ADDENDUM 4

ITB AP 59-20

CONSTRUCT BAGGAGE HANDLING SYSTEM AND WEST TERMINAL EXPANSION – DESTIN-FORT WALTON BEACH AIRPORT (VPS)

AE7-101

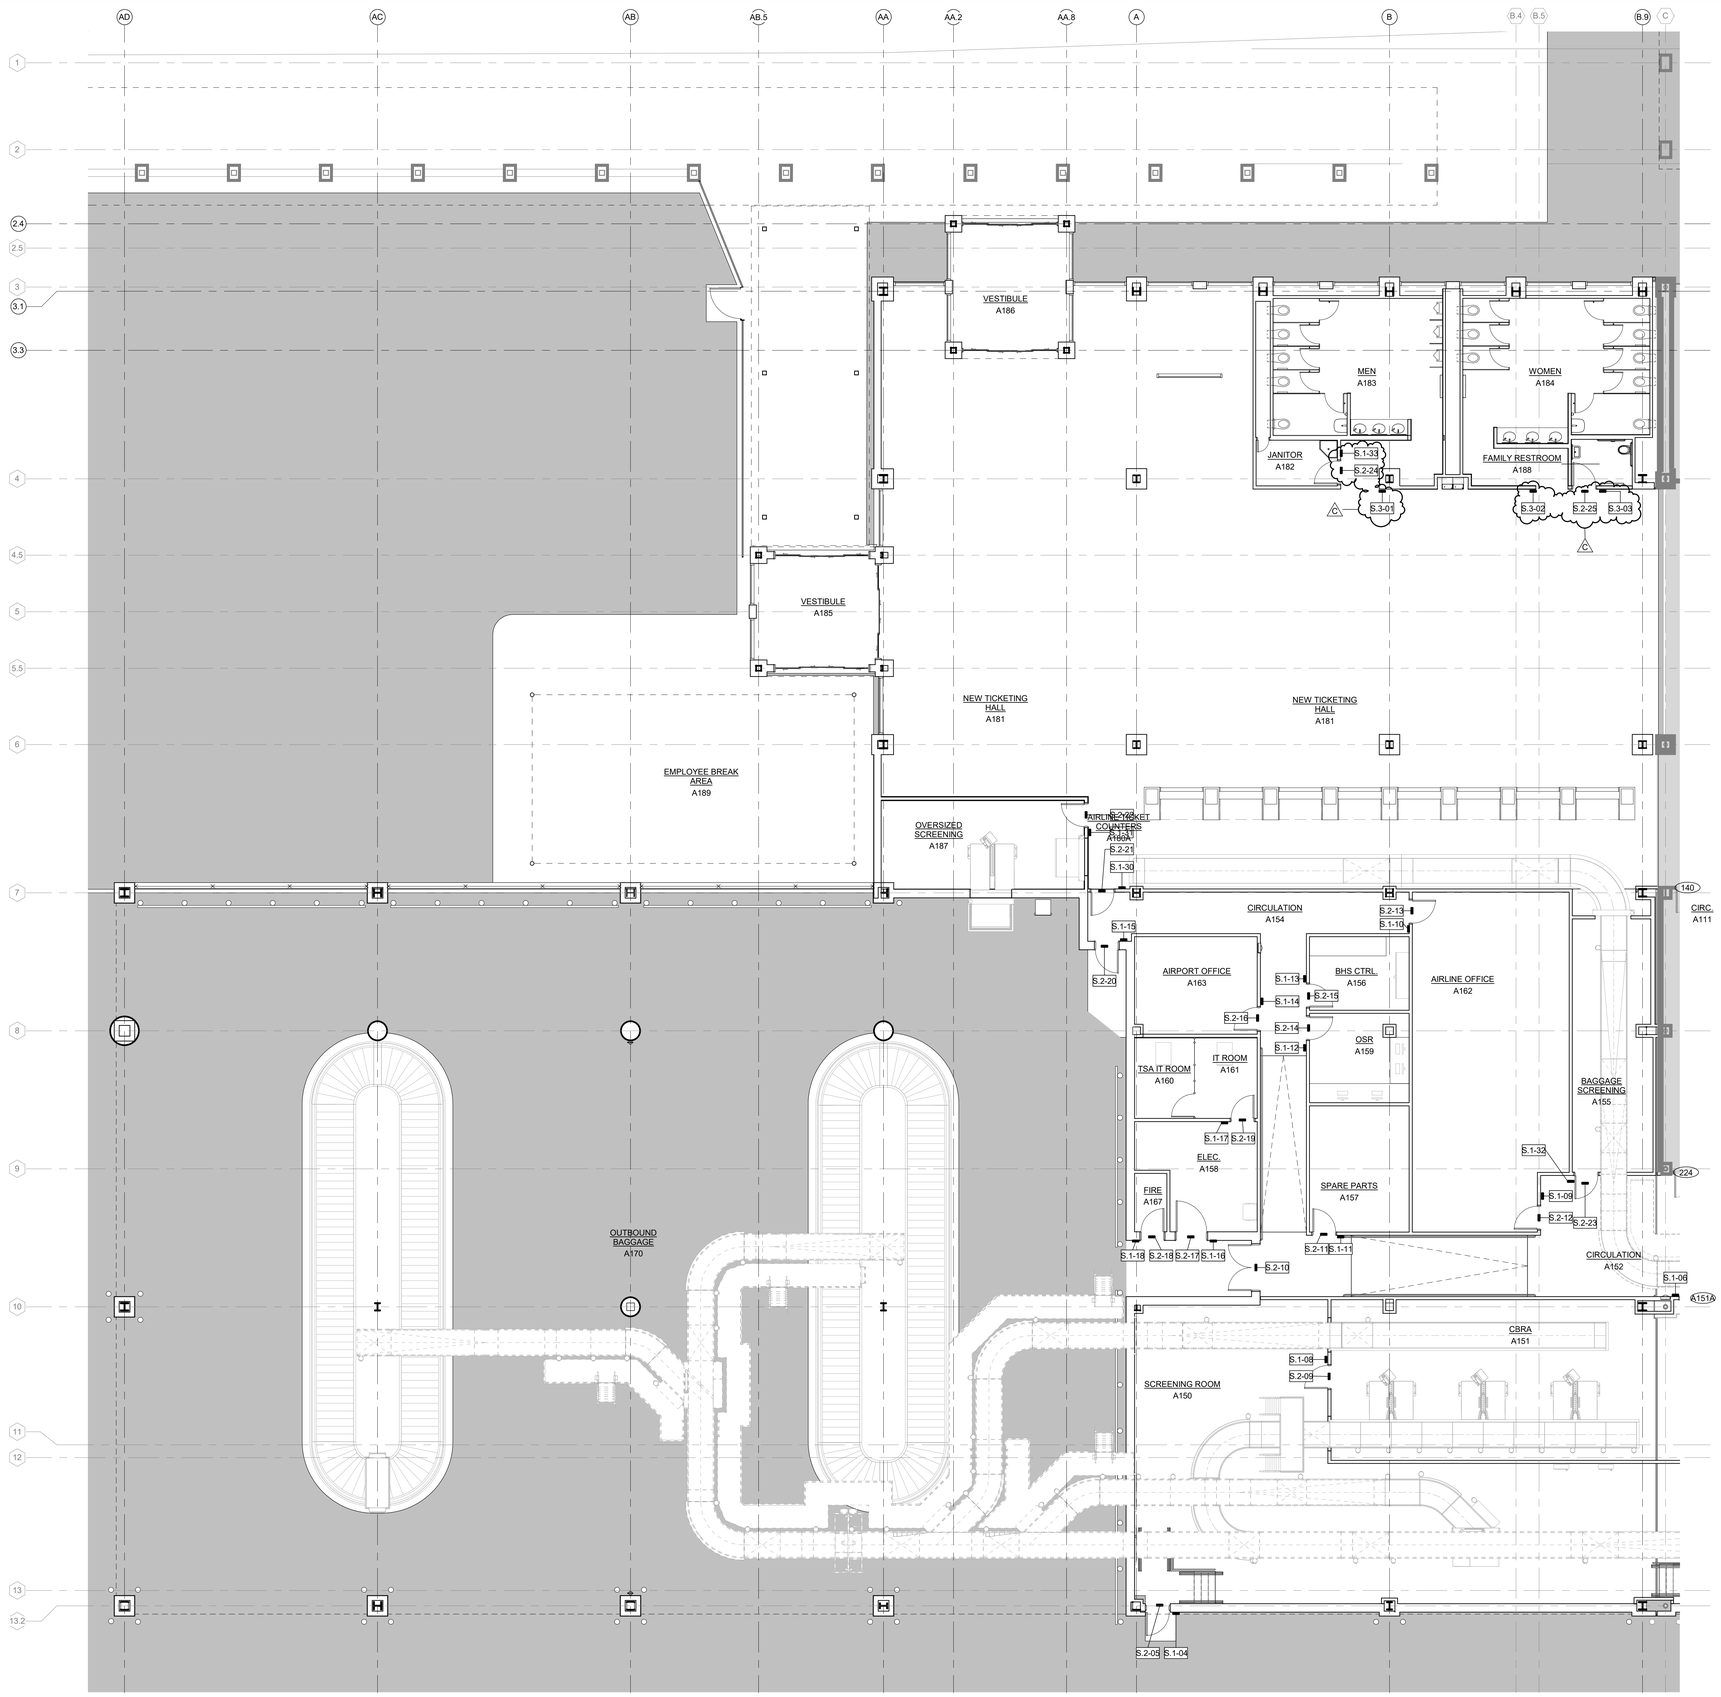
55. Sheet AE7-102 – There are no signs indicated for Toilet Rooms A183, A184, & A188. Normally toilet room signs are required before Certificate of Occupancy can be issued.
Answer: AE7-101 and AE7-102 will be updated to include room signage for A182, A183, A184, and A188.

QE1-101.1

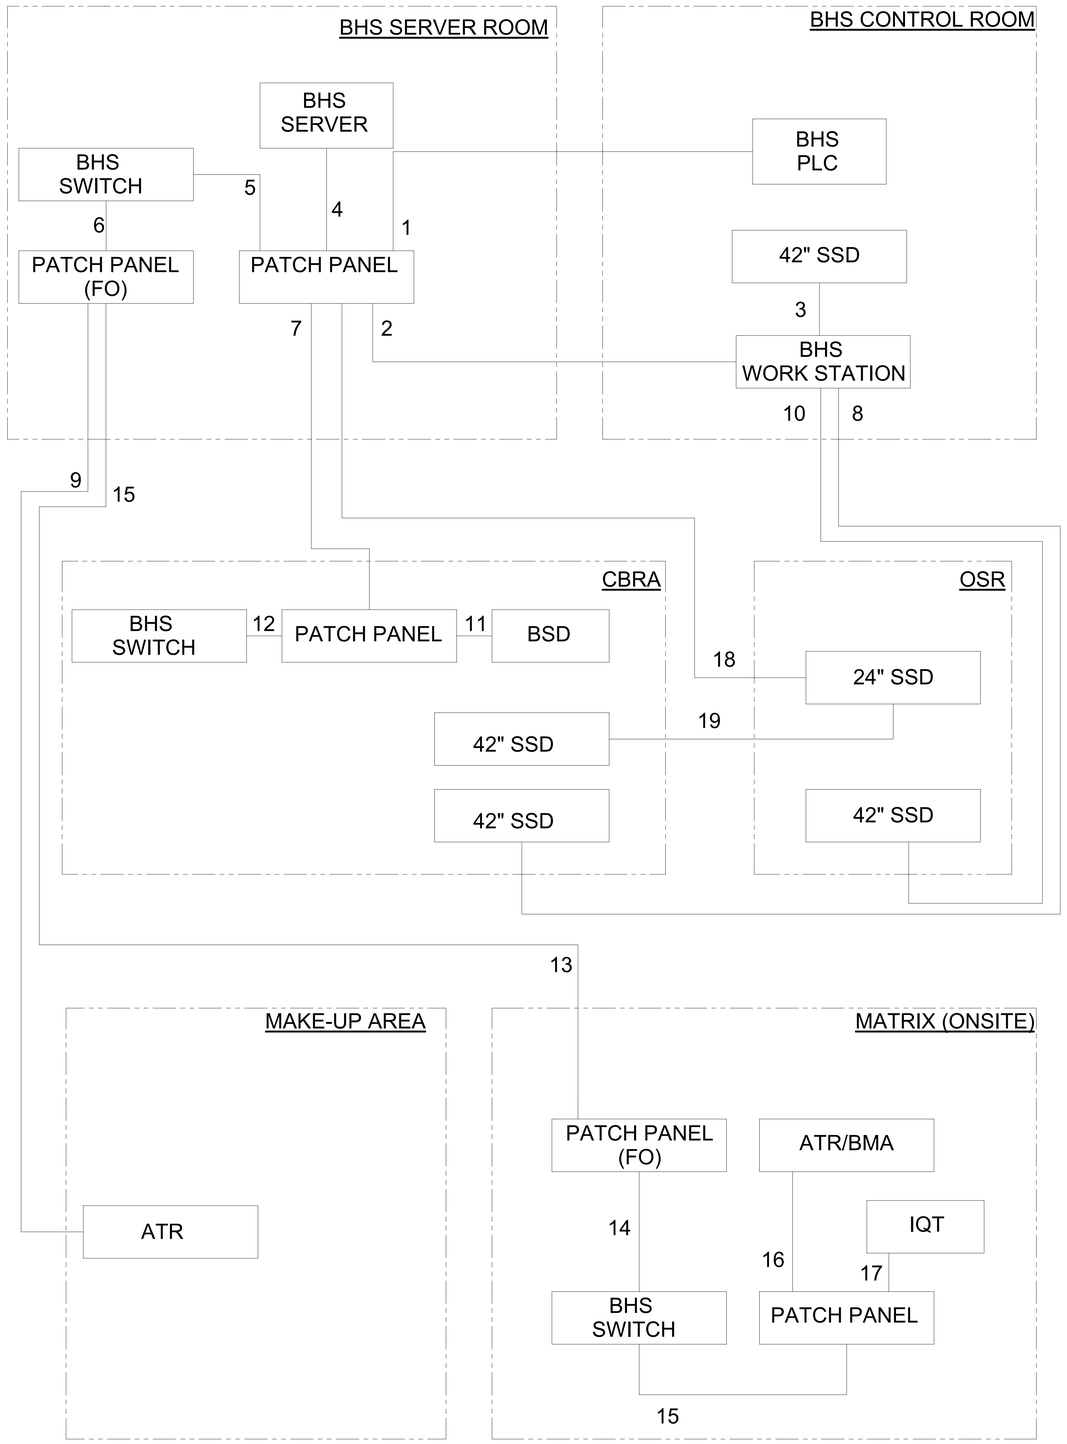
33. Drawings QE1-101.1 and QM7-101, Drawing QM7-101 shows a crossover at TC1-09. Drawing QE1-101.1 does not show a pair of Type 16 Control Stations for a crossover. Please confirm there is a crossover at TC1-09 that requires a pair of Type 16 Control Stations.
Answer: Confirmed.
